**WORCESTER COUNTY TECHNICAL REVIEW COMMITTEE
AGENDA**

**Wednesday, February 11, 2026 at 1:00 p.m.
Worcester County Government Center, Room 1102, One West Market Street,
Snow Hill, Maryland 21863**

A. 9529 Stephen Decatur Highway – Minor Site Plan Review

B. 589 Group Project – Major Site Plan Review

CRITICAL AREA LANDSCAPING PLAN
ISLAND TECH

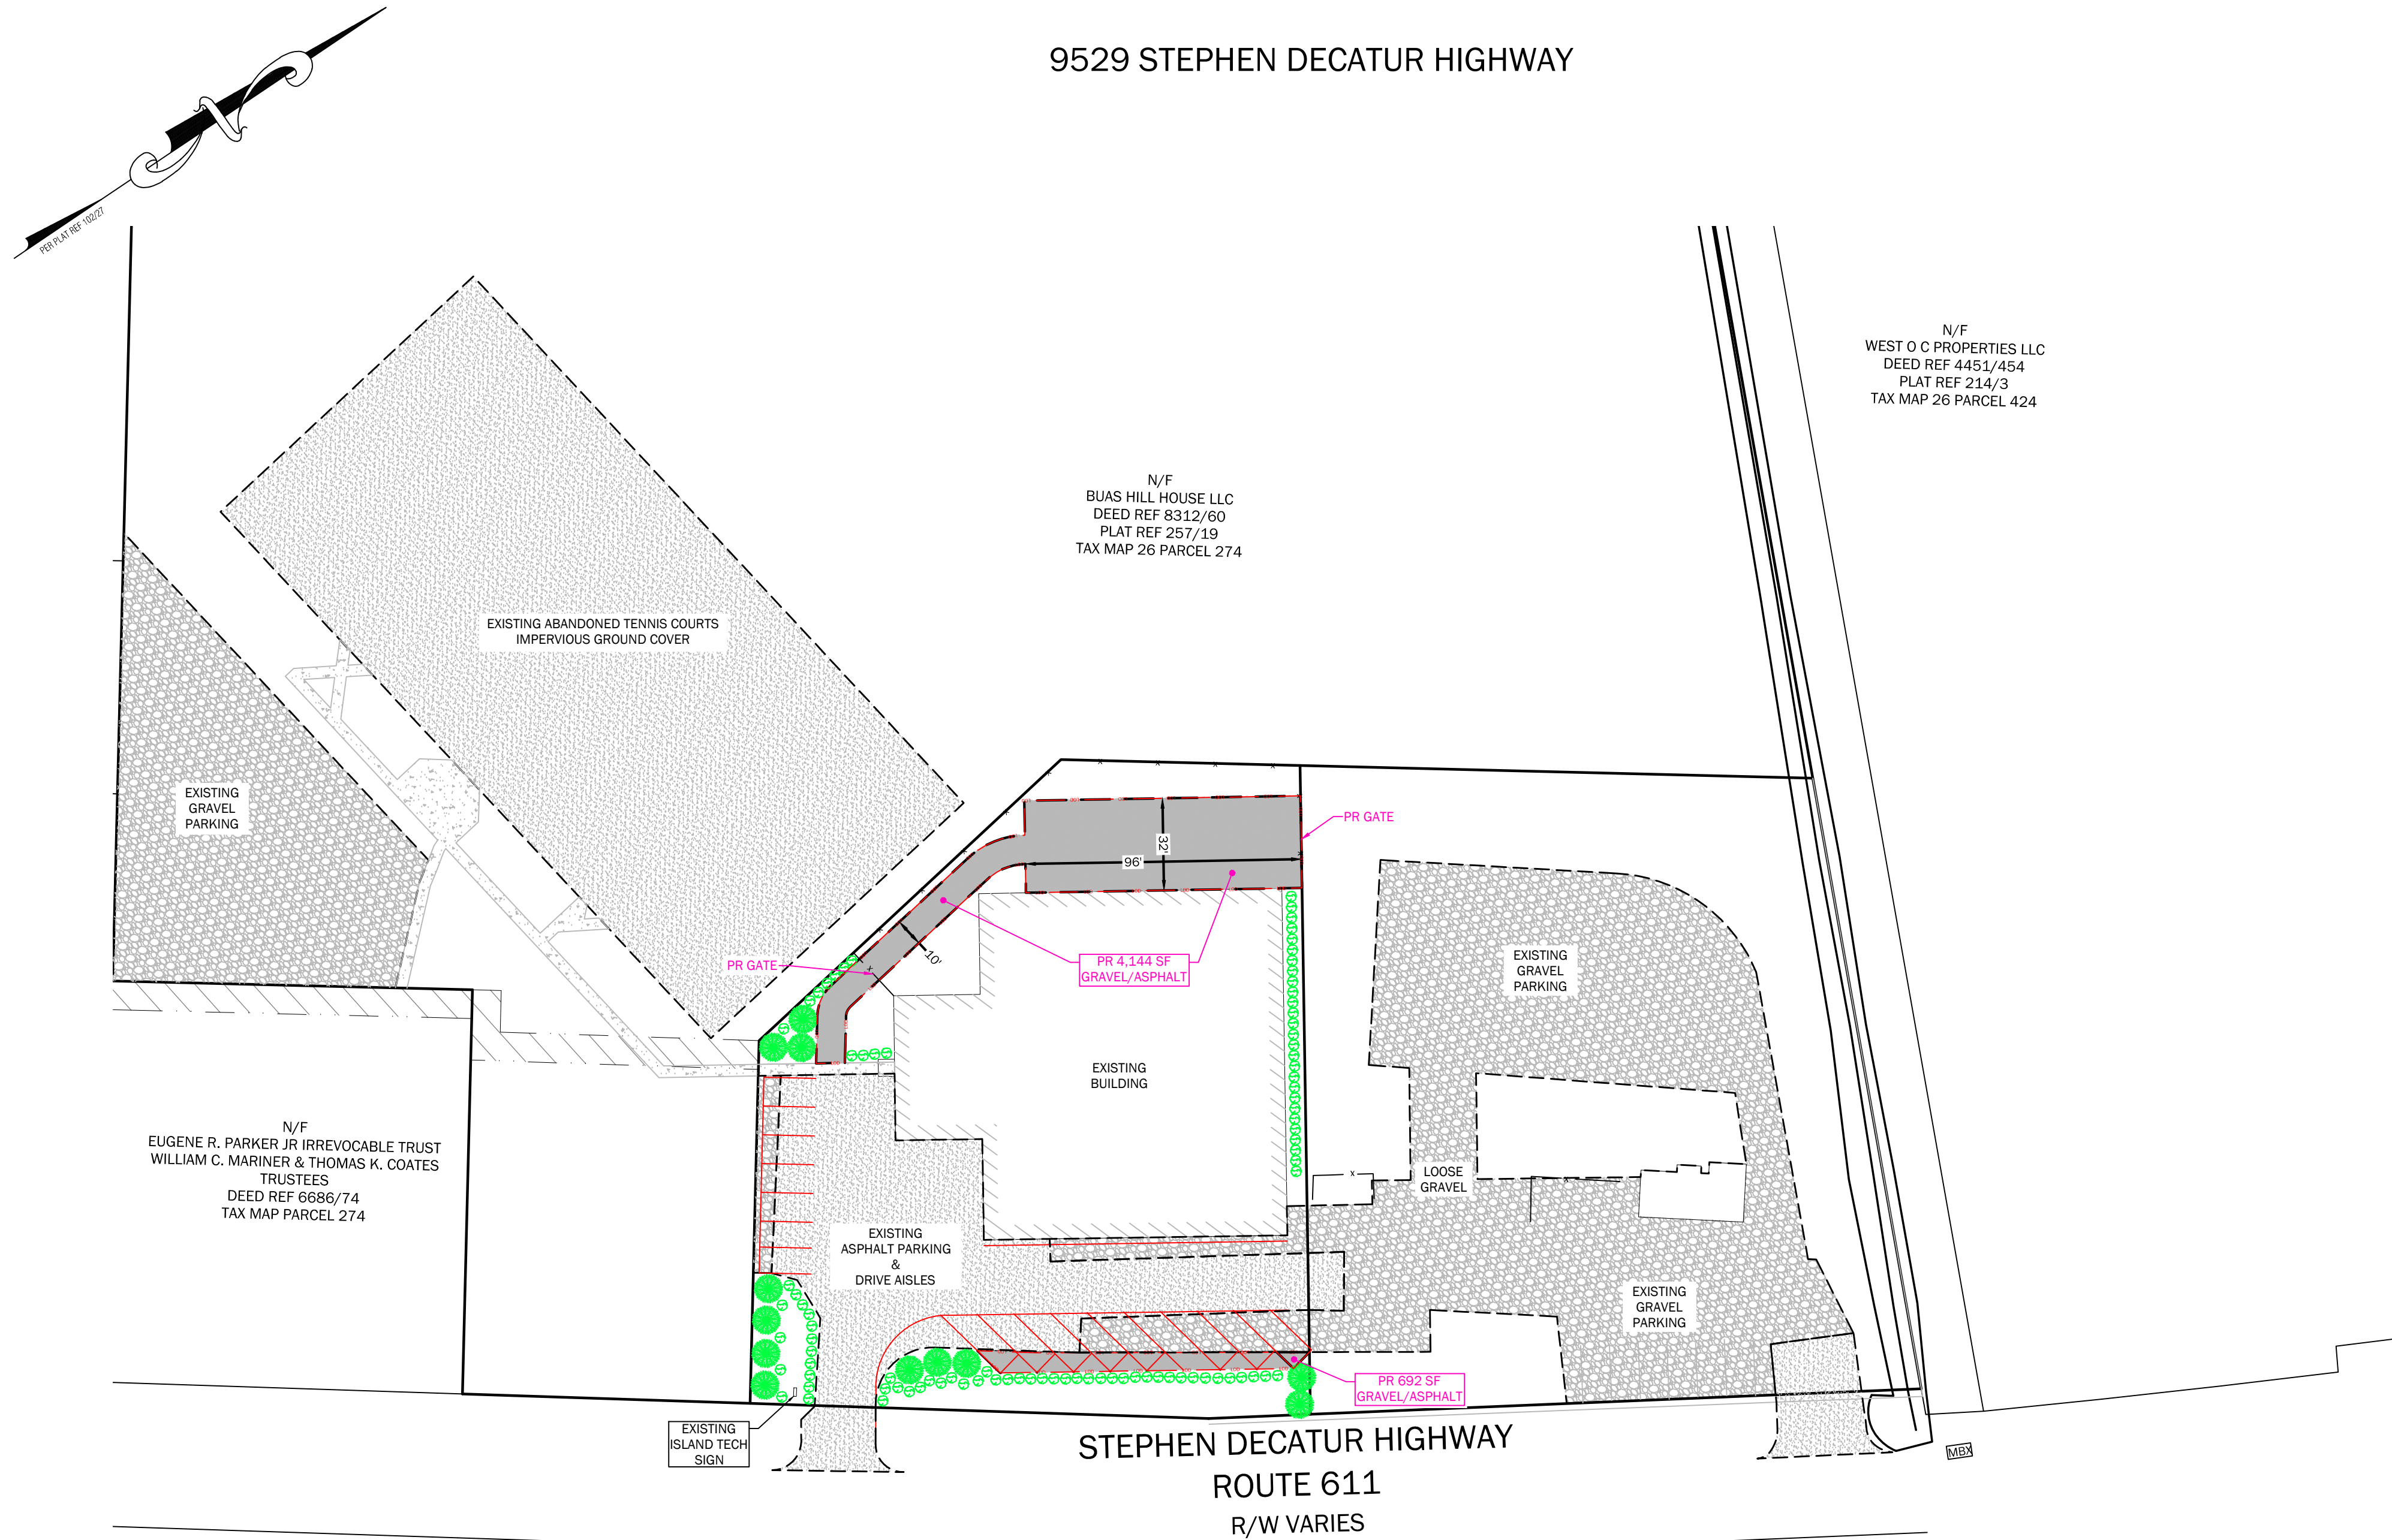
1. Please include the setbacks in the general notes.
2. Please demarcate the parking space dimensions, and please also provide a parking table.
3. Please add the vehicular travelway widths in the front parking lot.

4. Please confirm the final paving material when completed. Will it be gravel or asphalt? Please also add a legend for these materials.
5. Please confirm the height and location of the fencing, and please add the fence to the legend. Please provide a typical detail of the fencing.

6. Please clarify if loading spaces will be required. §ZS1-321. <https://ecode360.com/14021074>.
7. Please clarify if there is any existing or proposed exterior lighting on the property. §ZS1-323. <https://ecode360.com/14021144>.

1. Please provide the Critical Area designation of Intensely Developed Area (IDA) to the plan.
2. Add Atlantic Coastal Bays Critical Area note to read: **Worcester County Atlantic Coastal Bays Critical Area Law:** *This property lies within the Worcester County Atlantic Coastal Bays Critical Area. Any and all proposed development activities must meet the requirements of Title 3 (Land and Water Resources), Subtitle I (Atlantic Coastal Bays Critical Area) of the Worcester County Code of Public Local Laws, as from time to time amended, in effect at the time of the proposed development activities.*
3. Provide the total area of disturbance.
4. Provide a lot coverage calculation table.
5. Please submit the Critical Area review fee of \$150.00 for this Minor Site Plan.

| PROJECT DATA               |                 | REVISIONS                |  |
|----------------------------|-----------------|--------------------------|--|
|                            |                 | Sheet No: G 001          |  |

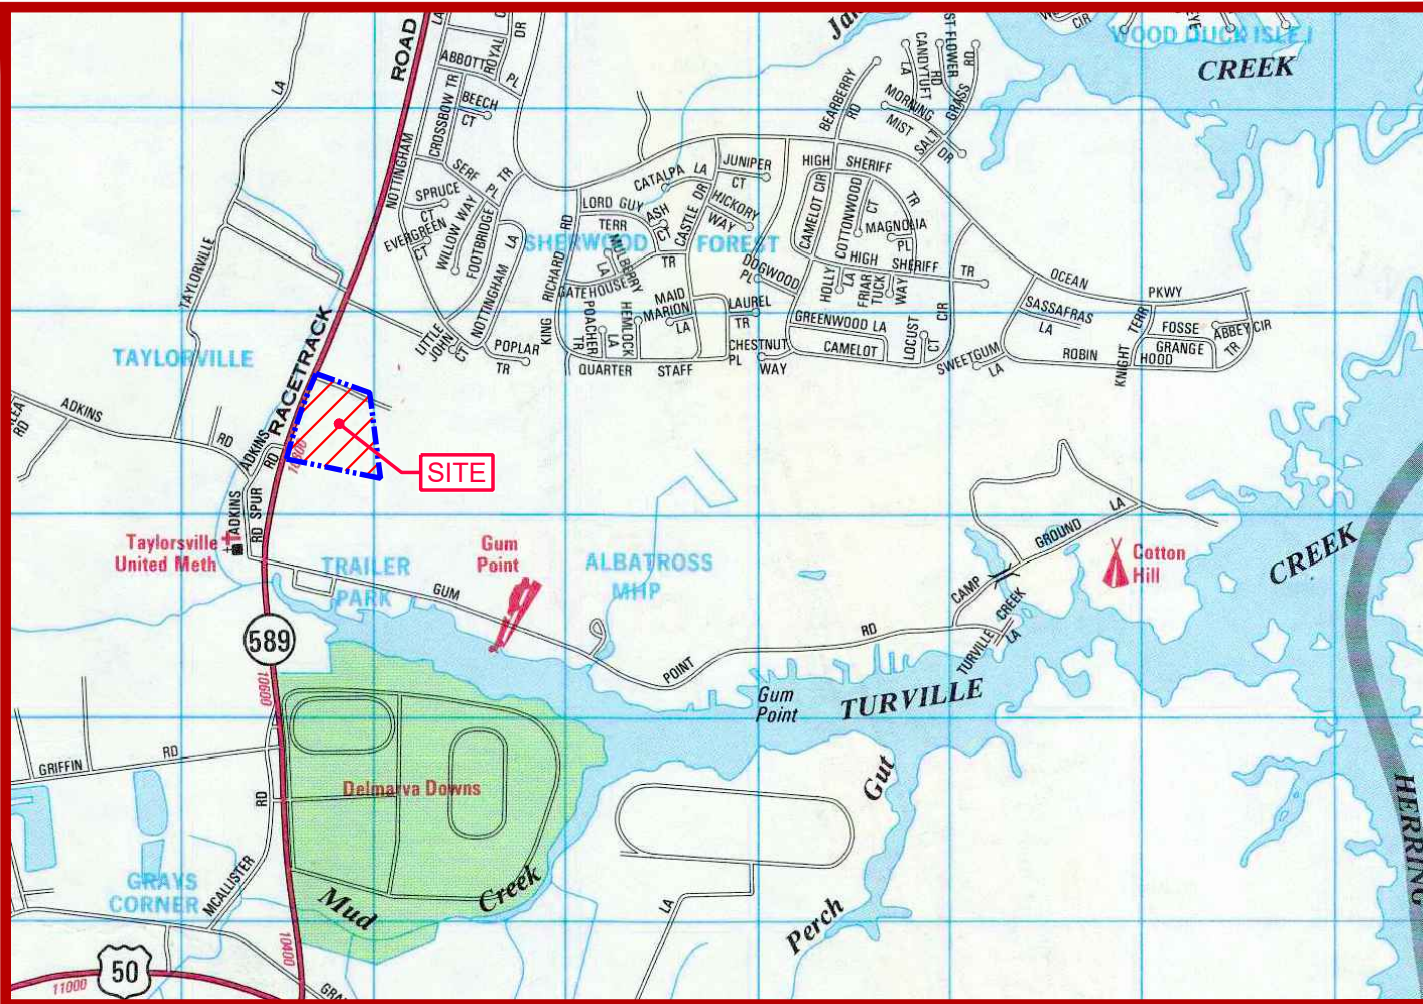
4. Sheet G001: Please add the setbacks for “Retail or service establishments” in the Zoning Information. §ZS1-210(b)(2). <https://ecode360.com/14019712>.

5. Sheet G001: Please include the bicycle racks that are shown on the plans on the parking table.
6. Sheet C201: Please revise the rear setback for Lots 2 and 4 from 25’ to 20’. §ZS1-210(b)(2). <https://ecode360.com/14019726>.

Sheet No: **C 200**

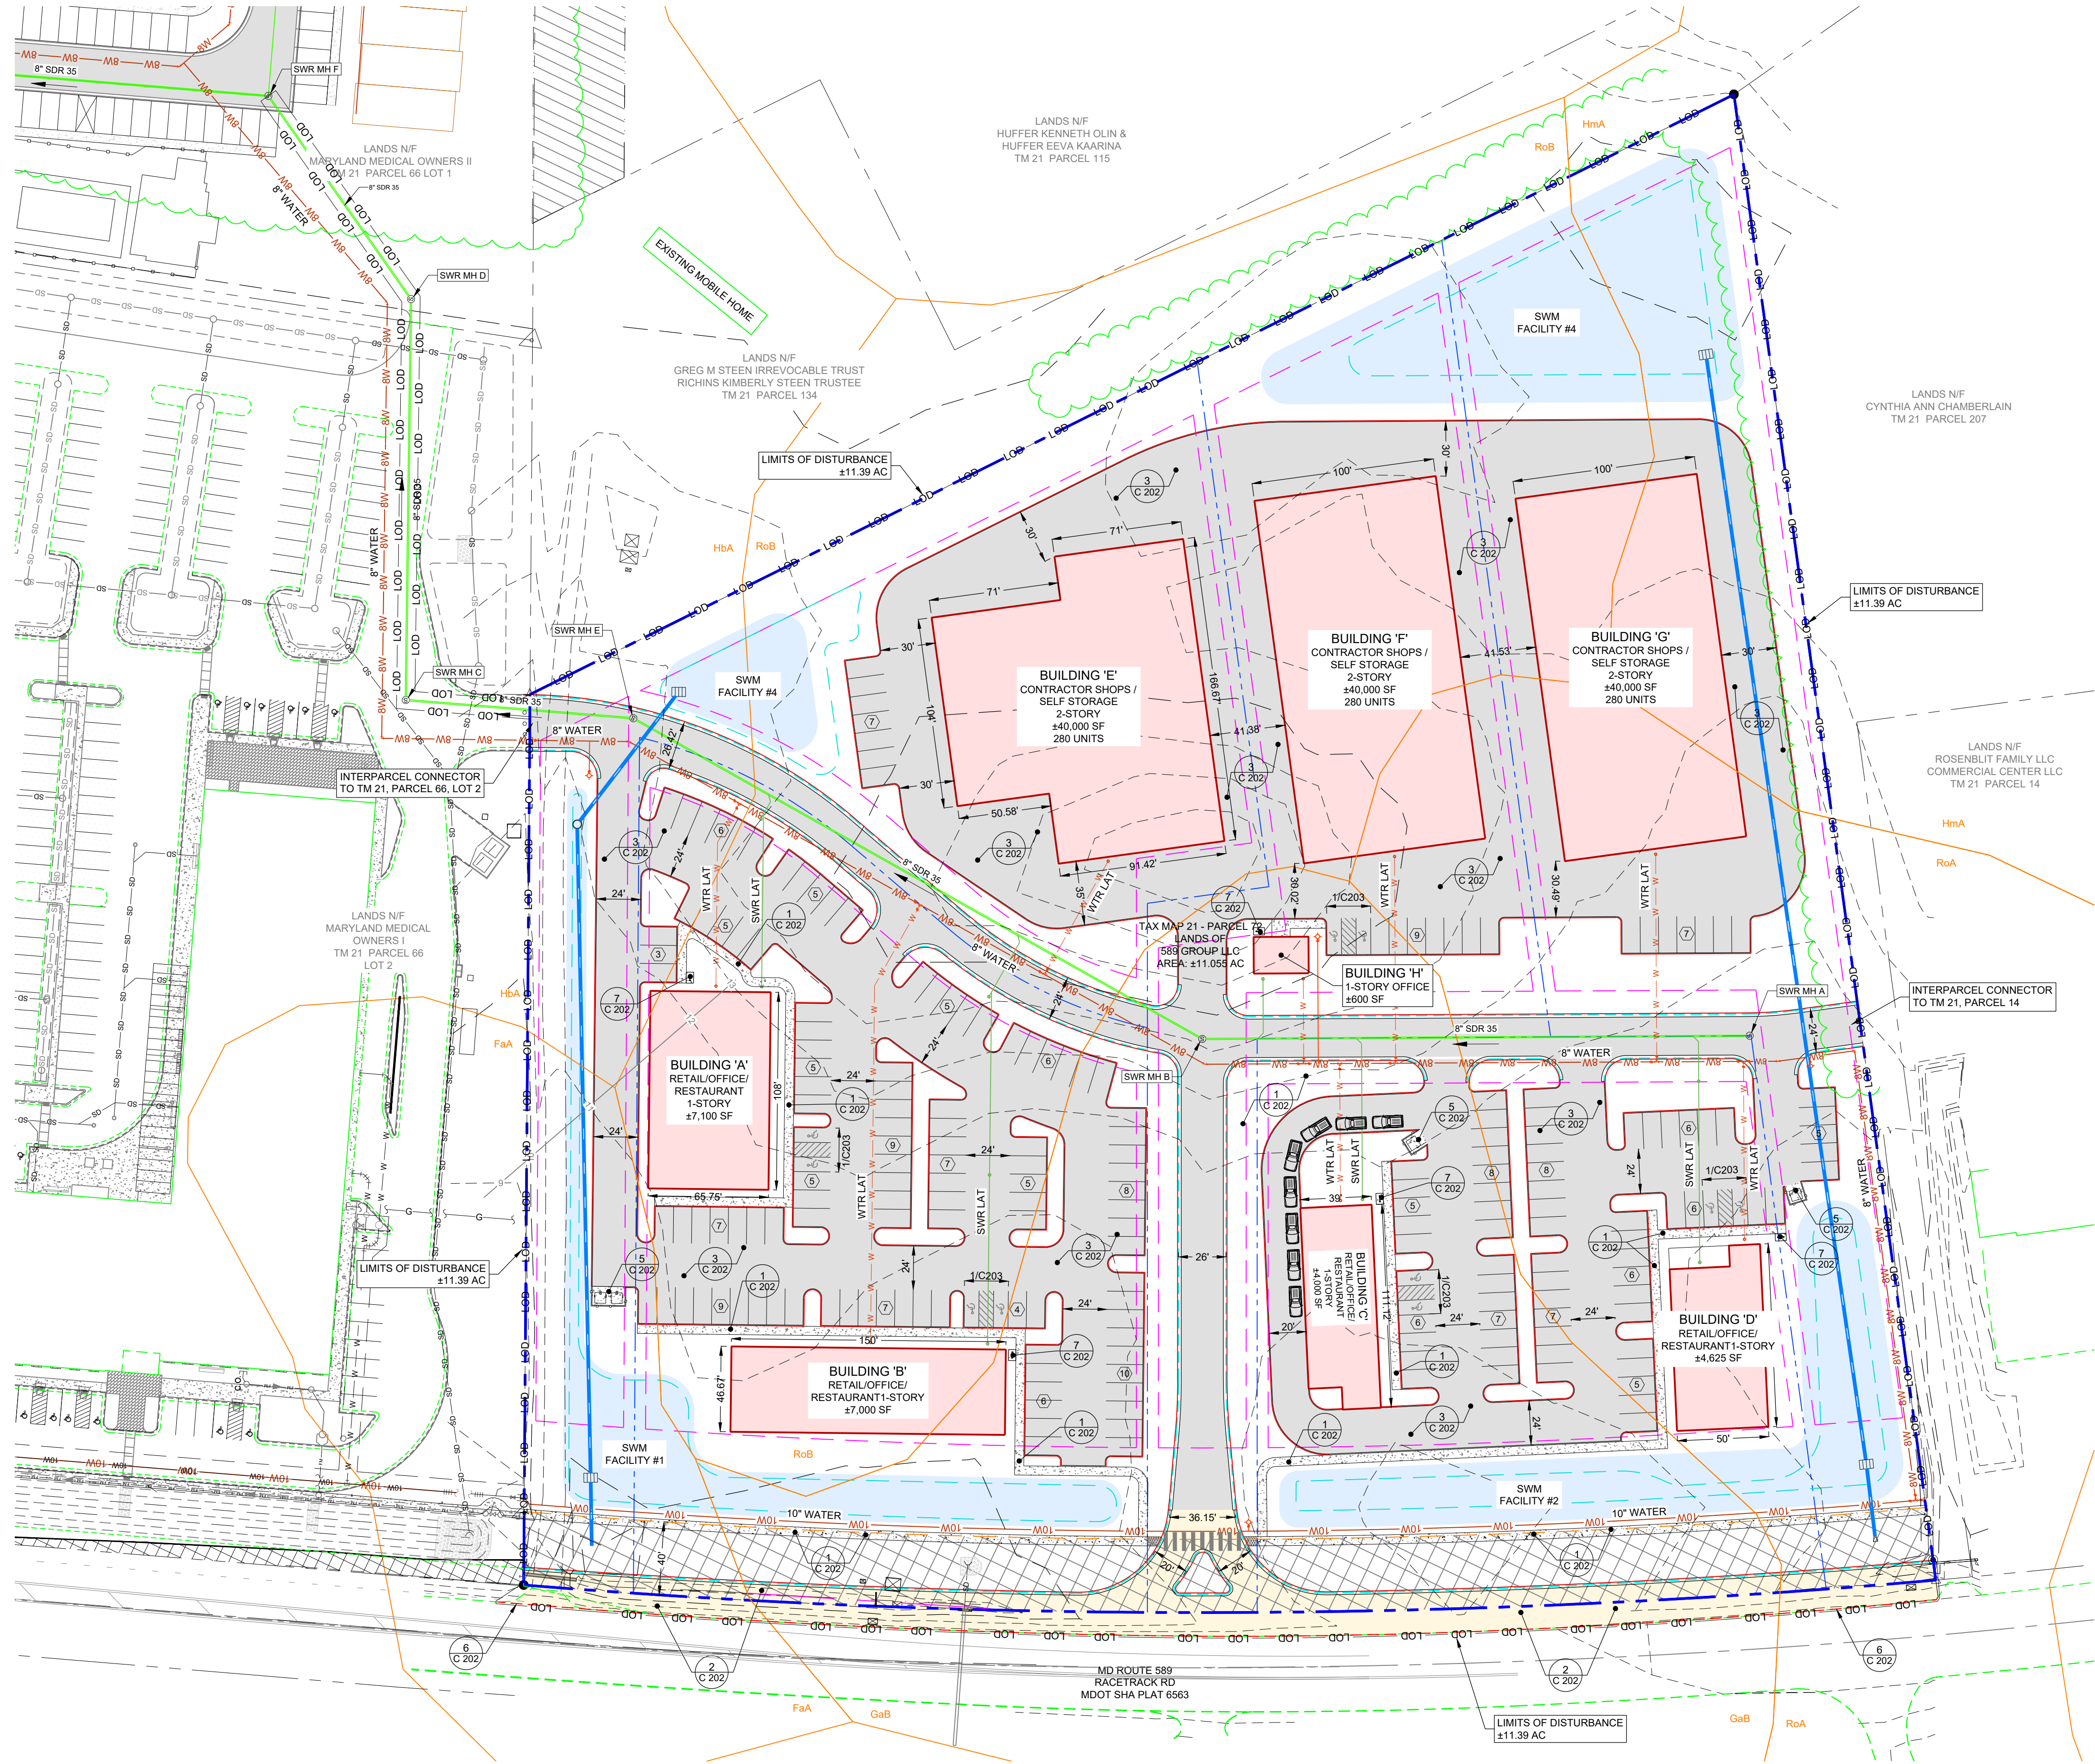
1. Please provide a phasing plan. The lot area table on Sheet C200 shows Lots 1, 3, and 5 are "current" while Lots 2 and 4 are "future." Please provide more details regarding the phasing of the buildings, parking, roads, landscaping, and stormwater facilities.
2. In phased construction, the first phase shall include the landscaping of property perimeters, entry drives, and stormwater management ponds as well as required parking lot and building landscaping. §ZS1-322(b)(9). <https://ecode360.com/14021091>.
3. Please add the zoning classifications of all adjacent parcels on all sheets, where applicable.

32. Approval of the site plan is contingent upon approval of the proposed subdivision as shown on Sheet C200.
33. Please provide colored building elevations of all buildings for Planning Commission review.
